SUBJECT: DONALD C. COOK NUCLEAR PLANT, UNIT 2 - ISSUANCE OF AMENDMENT  
TO REVISE TECHNICAL SPECIFICATION 3.3.2, ENGINEERED SAFETY  
FEATURE ACTUATION SYSTEM INSTRUMENTATION (CAC NO. MF6984)

SAFETY EVALUATION BY THE OFFICE OF NUCLEAR REACTOR REGULATION

AMENDMENT NO. 313 TO RENEWED FACILITY OPERATING LICENSE NO. DPR-74

DONALD C. COOK NUCLEAR PLANT, UNIT 2

The LAR includes the following MFPT functional diagram:

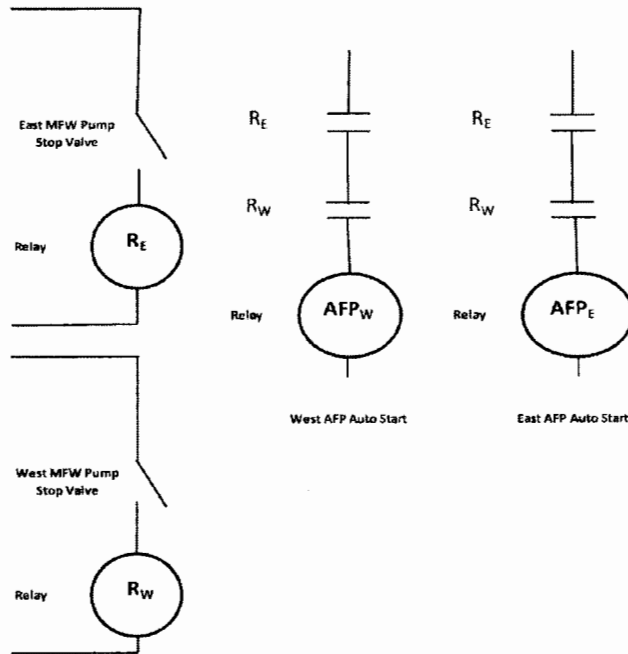
A MFW trip channel is considered to be the position indication switch, which closes when the associated MFW pump steam stop valve closes, along with the energization of the relay. The  $R_E$  and  $R_W$  relays for the MFW pump trip channels in CNP-2 provide input to the AFW pump actuation train logic. When the AFW actuation relay for either MFW pump ( $R_E$  or  $R_W$ ) is energized, a signal is sent to the AFW pump actuation logic circuit. The AFW pumps will start when signals from both MFW pump channels have been received by the AFW pump actuation logic circuit.

The LCO requires one channel per pump to be operable. This function does not meet the single failure criteria, however this is acceptable since the SG water level low-low function is credited to start the AFW system in the analyses of design basis accidents and transients that result in a loss of MFW. Although a trip of all MFW pumps starts the motor-driven AFW pumps, the trip of all MFW pumps to initiate AFW is not credited in the CNP-2 safety analysis.
